REMARKS/ARGUMENTS

AMENDMENT TO THE DRAWINGS

ANNOTATED MARKED-UP
DRAWING

FIG.6

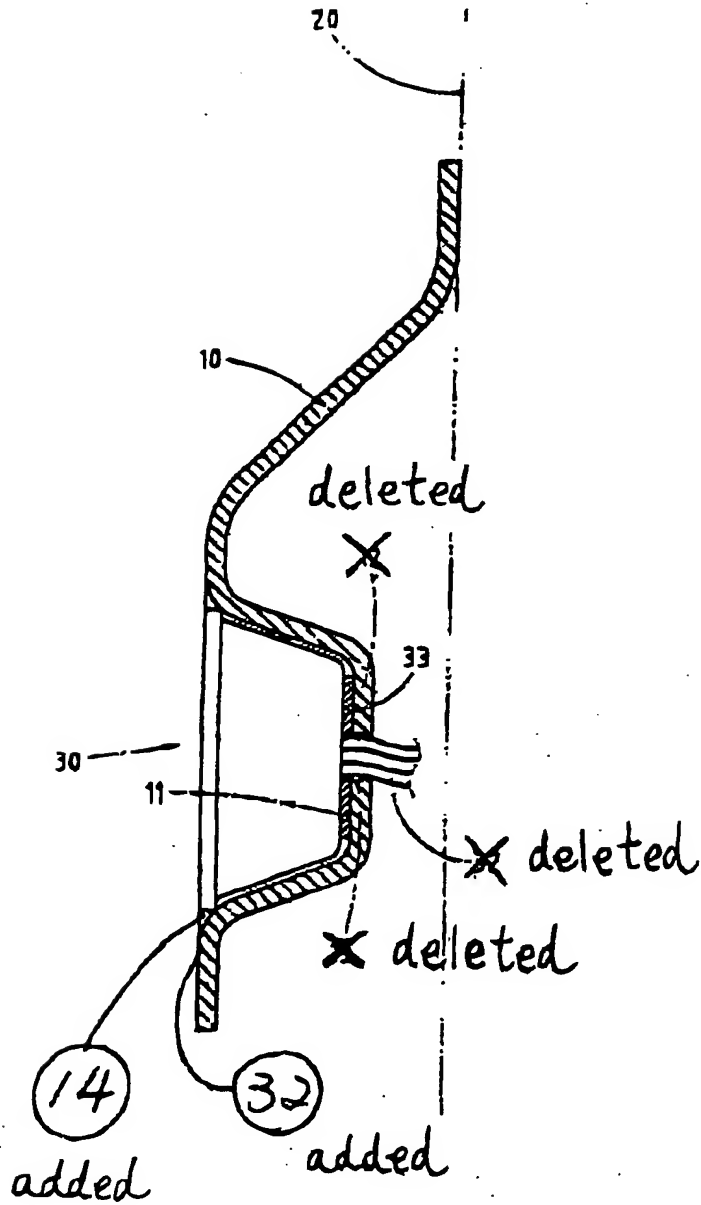
The drawings were originally objected to because Figures 5 and 6 do not match.

Replacement sheet is enclosed for the Examiner's approval. The attached sheet includes changes to Fig. 6. This replacement sheet replaces the original sheet. In figure 6, previously omitted element 14 has been added, and original elements 12 and 13 have been deleted. Besides, the position of element 32 has been corrected to pass through element 14. Besides, the bottom wall of element 11 has been corrected to have a closed shape. Besides, the wall of element 33 has been corrected to have a closed shape.

Responsive to this, Figure 6 is corrected to match Figure 5 in accordance with the Examiner's instruction and suggestion, and it is believed that the objection should be removed.
